**RE: MOOLARBEN OC3 EXTENSION PROJECT – INDEPENDENT EXPERT ADVISORY PANEL FOR MINING
PRELIMINARY REQUEST FOR ADDITIONAL INFORMATION**

**MOOLARBEN OC3 EXTENSION PROJECT – INDEPENDENT EXPERT ADVISORY PANEL FOR MINING PRELIMINARY
REQUEST FOR ADDITIONAL INFORMATION RECONCILIATION TABLE**

RE: Moolarben OC3 Extension Project - Independent Expert Advisory Panel for Mining - Groundwater Responses

ATTACHMENT 1 – DEPTH TO BASE OF ULAN SEAM

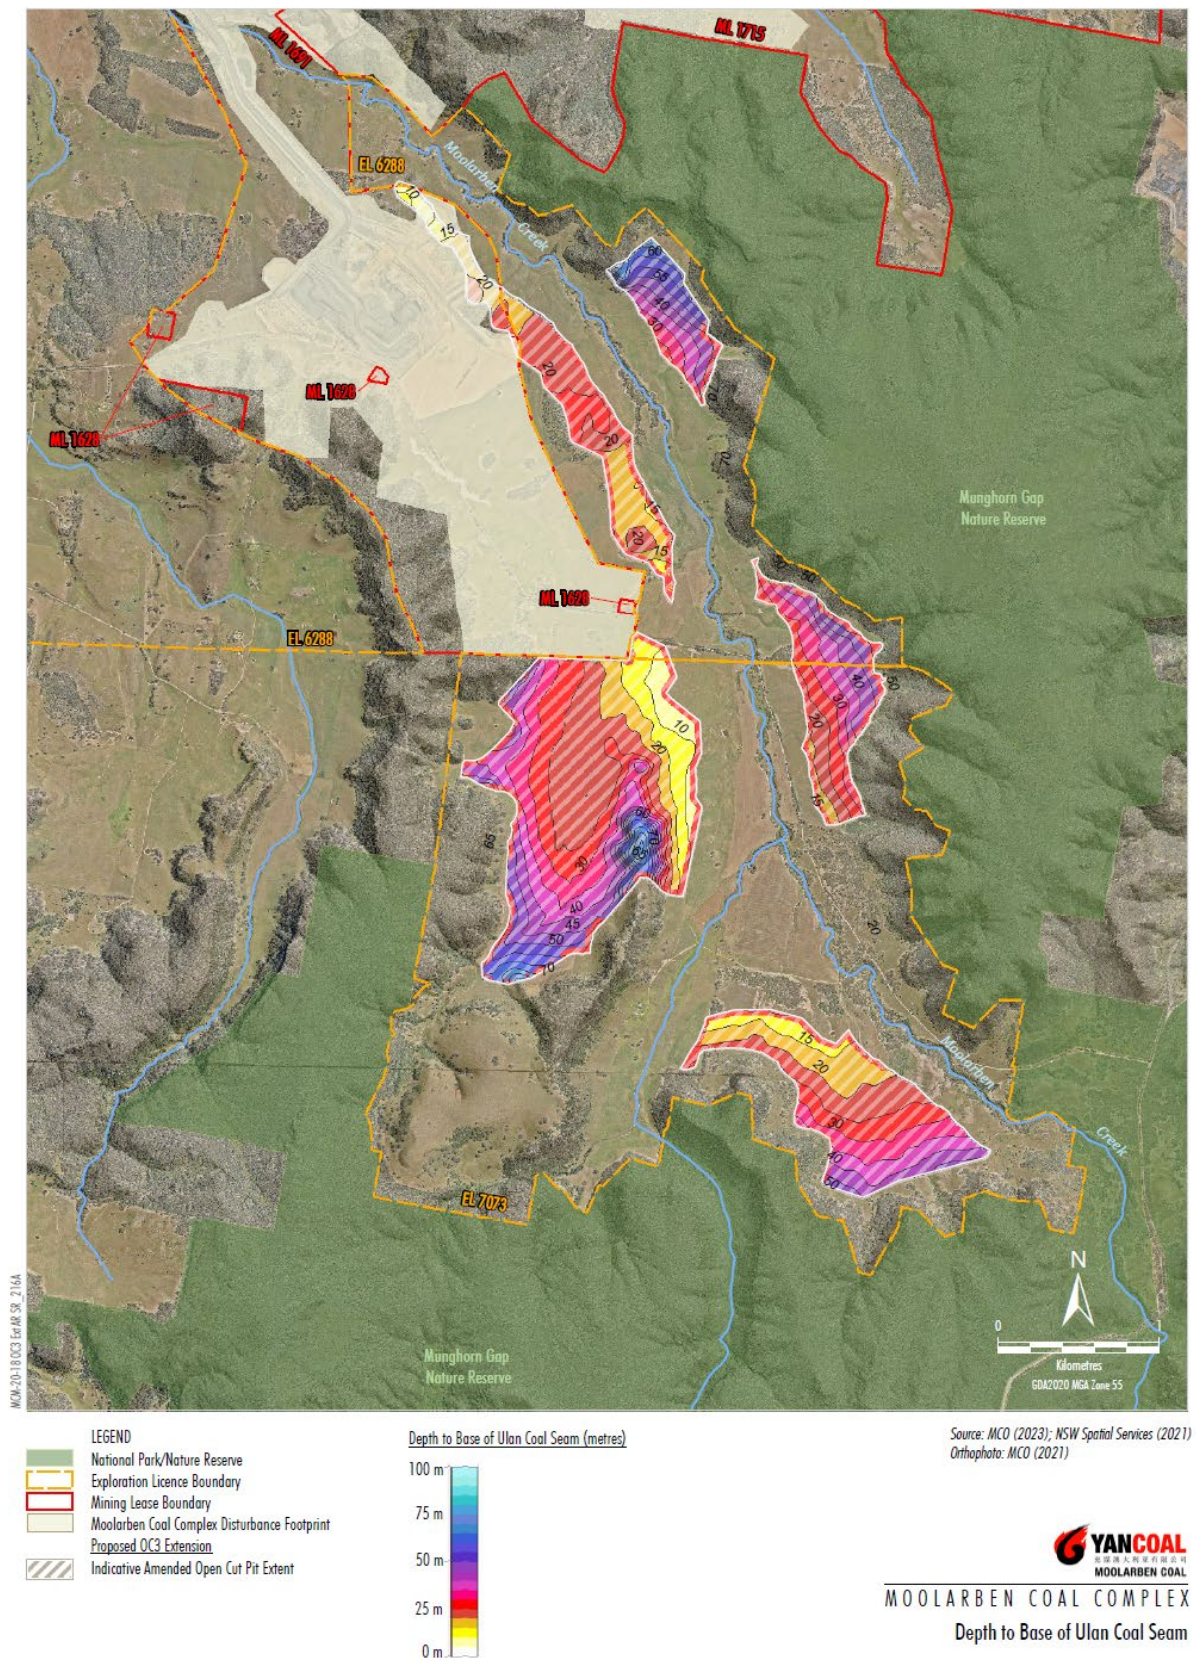
Coordinates of gas content test boreholes.	
b. Geology	Confirmation/description of geology (is the Ulan seam the only seam, depth of cover maximum 100 m).	- Within the amended Project open cut pit extents, the depth of cover ranges from ~10 m to ~70 m (Attachment 1 of this response). - A general description of the geology and working sections are provided in the Project Description¹: <i>The Ulan Seam is divided into five key working sections (i.e. A1, WS1, WS2, ELWR and G) that are separated by recognised partings. The Illawarra Coal Measures are overlain by the Triassic Narrabeen Group (locally known as the Wollar Sandstone) and comprise mainly conglomerate and sandstone. The Ulan Seam typically ranges from 2.5 to 7.5 m thick in the Project area. Typical thickness of recovered coal plies mined by the existing Moolarben Coal Complex is 5.5 m in total, with various interburden thicknesses between plies.</i> - Further detail is provided in Section 4 of the EIS Groundwater Assessment².

Information Required		Response
Greenhouse Gas		
a. Gas content	Formal reports on gas content and gas composition testing for the underground and open cut areas.	- The target coal seams at the Moolarben Coal Complex and the Project area are very shallow (Figure 4-18 from the Submissions Report, repeated as Attachment 1 to this response). - Within the amended Project open cut pit extents, the depth of cover ranges from ~10 m to ~70 m. This is consistent with historical open cut mining operations at the Moolarben Coal Complex. - The Ulan Seam has a very low gas content, and the gas composition is largely CO₂ (i.e. very low methane). - The existing Moolarben Coal Complex reports annual emissions under the <i>National Greenhouse and Energy Reporting Act 2007</i> (NGER Act). - Fugitive emissions from the open cut extraction of coal are estimated using Method 2 under the <i>National Greenhouse and Energy Reporting (Measurement) Determination 2008</i> and the <i>Guidelines for the Implementation of NGER Method 2 or 3 for Open Cut Coal Mine Fugitive GHG Emissions Reporting (C20005)</i>, published by the Australian Coal Association Research Program (ACARP Guidelines). - Method 2 relies on measurements of in situ gas content and composition from drill cores and gas domain modelling. The most recent gas drilling and sampling program was undertaken by GeoGAS in 2021 and included drillholes within the Project Area. These results indicate that the gas properties for the Ulan Seam are relatively uniform across the Moolarben Coal Complex. - A site-specific fugitive emissions factor of 0.0009 t CO₂-e/t ROM has been used in the calculation of greenhouse gas emissions for the amended Project. This factor is based on recent NGERs data for the open cut operations. - For comparison, the default Method 1 fugitive emissions factor for NSW is 0.061 t CO₂-e/t ROM.

FIGURE No:
25

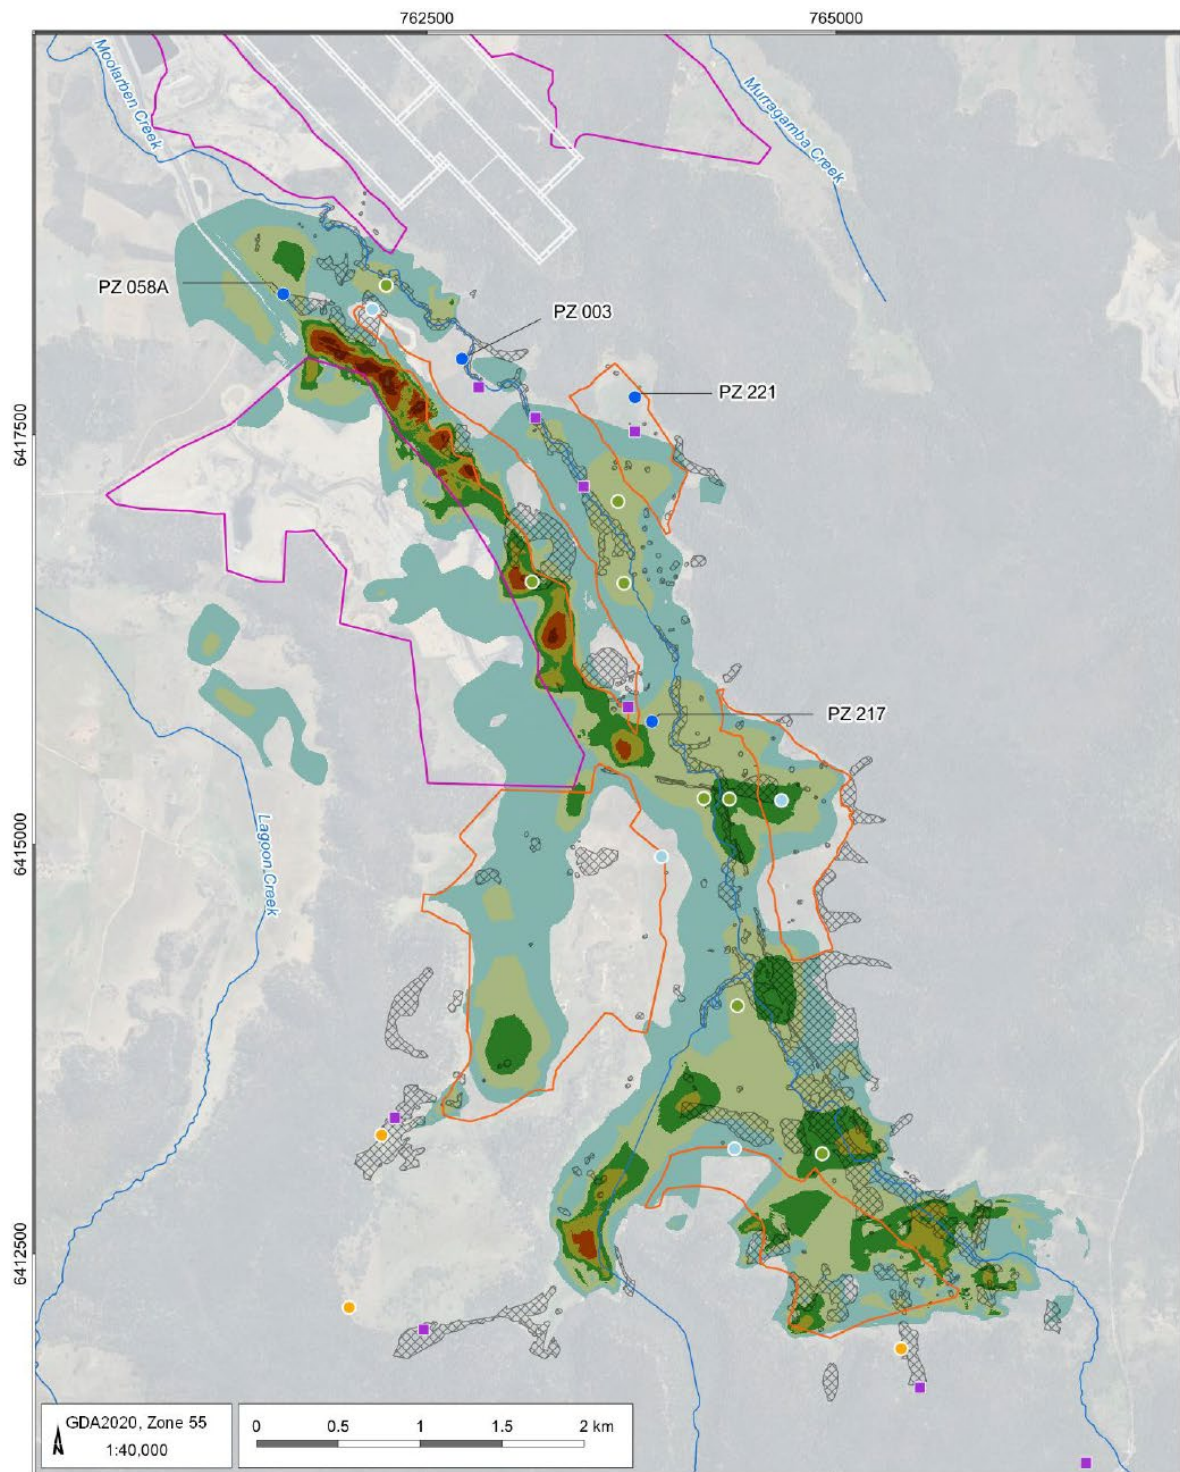
Information Required		Response
Are any additional alluvial monitoring bore sites being proposed as per the IESC advice recommendations?		- Yes, a number of new bores in the Alluvium/Tertiary Palaeochannel are proposed, as per Figure 25 of the Groundwater Review⁷ for the Amendment Report (which is consistent with Figure 8.1 of the EIS Groundwater Assessment) (see also Attachment 4 of this response). - It is noted the Water Group within DCCEE (previously DPE Water) stated in its Submission (emphasis added): <i>All the SEARs relevant to groundwater impact have been satisfactorily addressed in the Groundwater Assessment report.</i> <i>The impact of the project on groundwater and its receptors was estimated using Modflow-USG groundwater model that was independently peer reviewed as fit for the purpose.</i> <i>Nevertheless, DPE Water assessed the groundwater model as acceptable with 66% rating.</i> <u><i>DPE Water agrees with the selection of proposed monitoring sites and the proposal to update the approved WMP for MCC once baseline information of the proposed monitoring sites are analysed.</i></u>

Are any new Permian overburden/Ulan seam monitoring bores proposed to validate the model predictions? If so, where?		- Existing groundwater bores PZ003, PZ221 and PZ217 are all screened in the Ulan Seam and monitoring data from these bores would be used to validate the model predictions. - These bores are shown on Figure 25 of the Groundwater Review for the Amendment Report (which is consistent with Figure 8.1 of the EIS Groundwater Assessment) (see also Attachment 4 of this response).

FIGURE No:
2.1

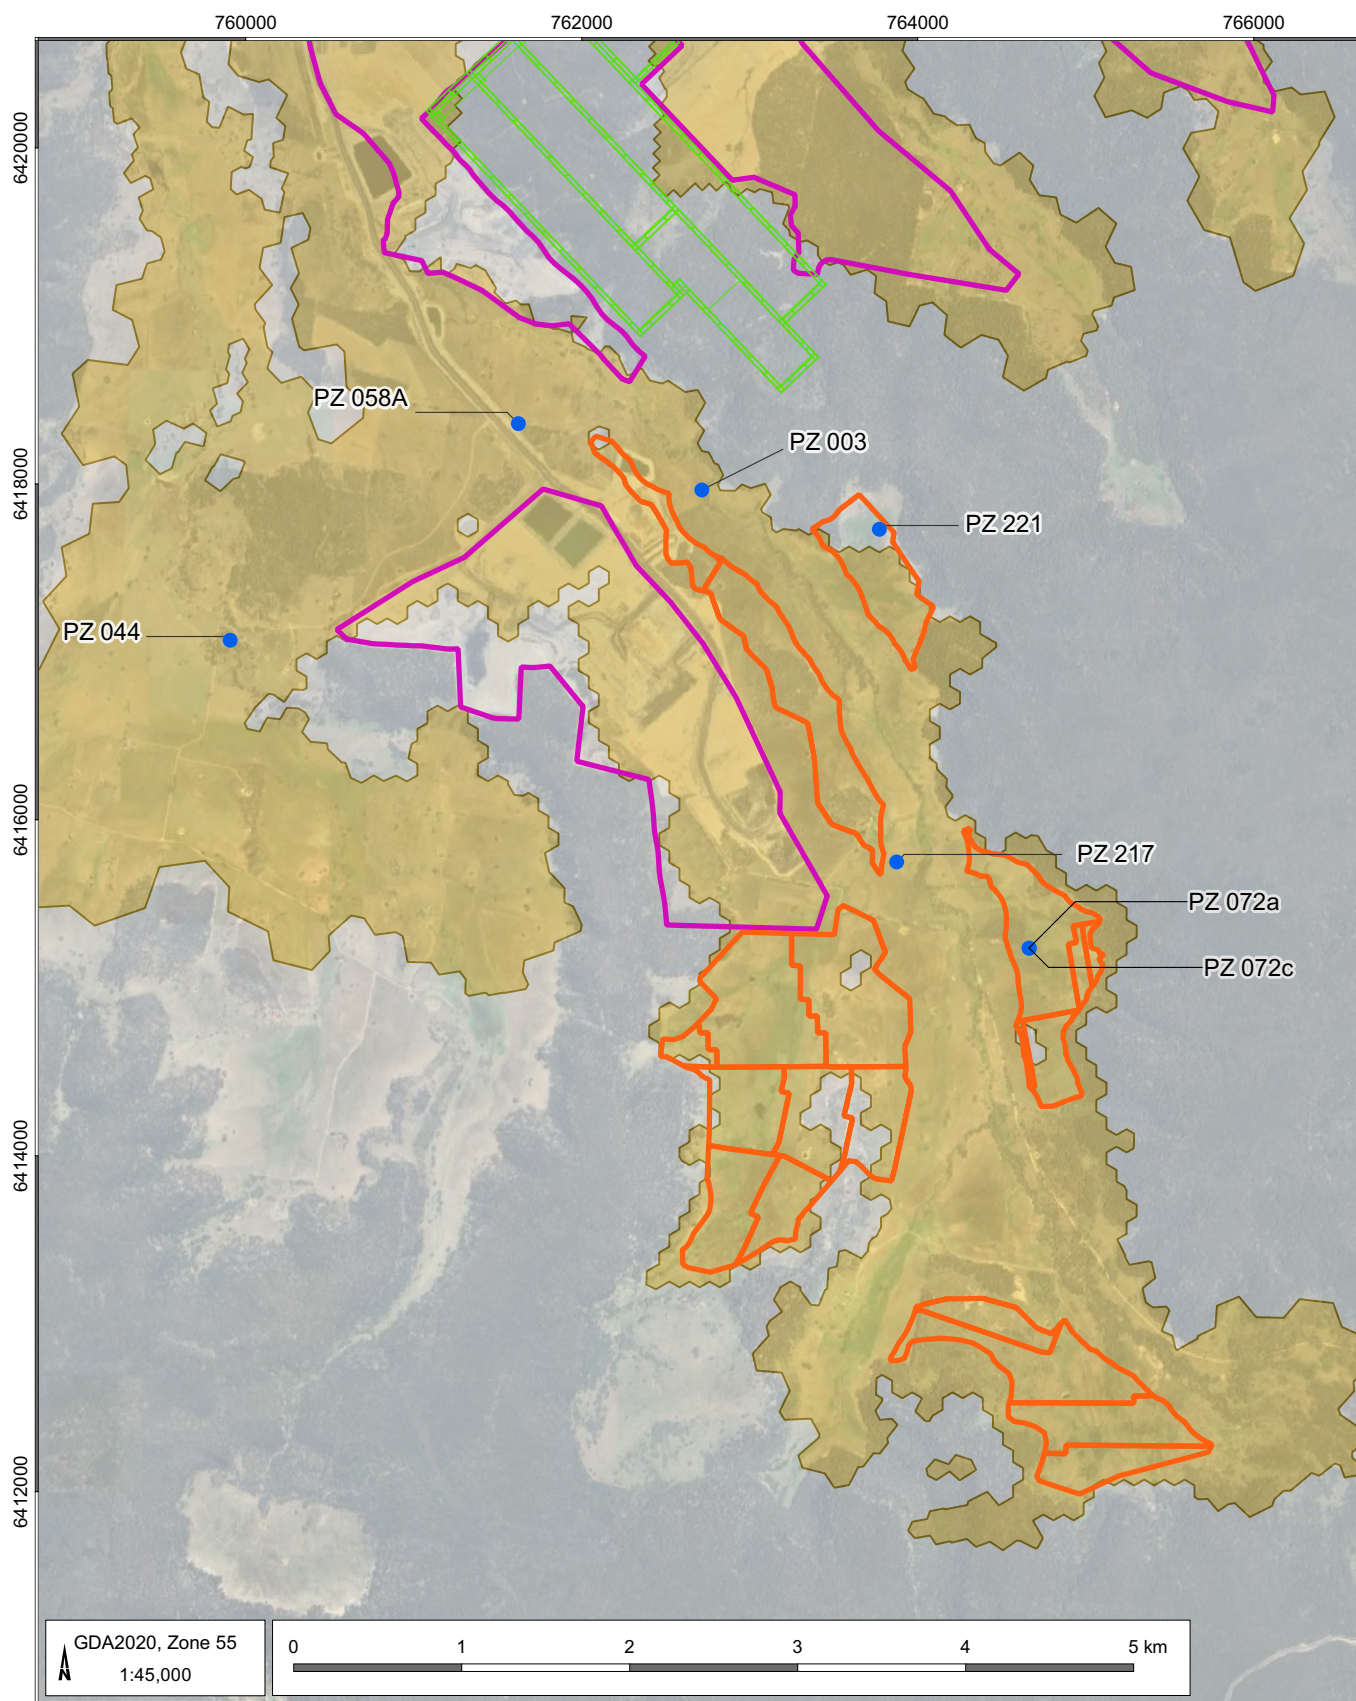
- *Can the Panel please have access to the monitoring data to support the claim that “large areas of the project are currently unsaturated, limiting the potential for impacts associated with changes in groundwater levels”?*

Figure 2-1 shows the seven (7) groundwater monitoring bores located in the vicinity of the Project area and Table 2-1 summarizes the construction details. Apart from bore PZ058A and bore PZ072C, which are screened in the Tertiary sediments, the monitoring bores are screened in the Ulan Seam. This bore construction is generally adopted when drilling indicates unsaturated conditions occur within the alluvial deposits at the time of installation.

Figure 2-2 PZ003 recorded groundwater levels and CRD curve

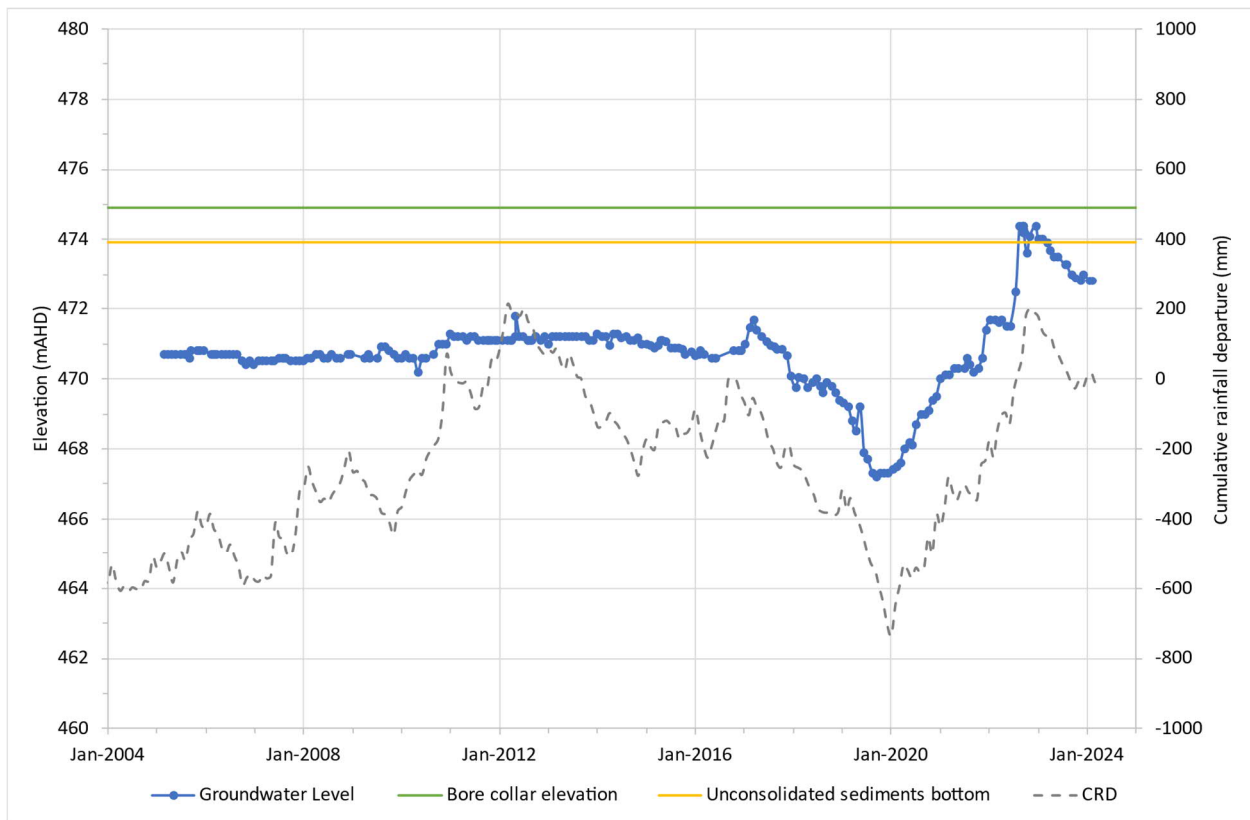
- Can the Panel please have access to the data to support the claim that the “variability in groundwater levels of around 5 m due to climatic variations” in existing monitoring bores?

The charts show consistently unsaturated conditions within the unconsolidated deposits at monitoring sites PZ044 and PZ221. At monitoring site PZ003 the unconsolidated sediments were saturated for a short period of time in late 2022/early 2023 (coincident with extended wet periods). Monitoring sites PZ058A, PZ072A, PZ072C and PZ217 show permanent (or almost permanent at P072A) saturated conditions within the unconsolidated sediments, noting that P072A and PZ217 are screened within the Ulan Seam formation.

As shown in Figure 2-2 and Figure 2-3, groundwater levels at monitoring sites PZ003 and PZ044 display a consistent response to climatic conditions as indicated by the correlation with the CRD. The charts show climatic stresses have result in groundwater levels at these bores varying by around 5 m.
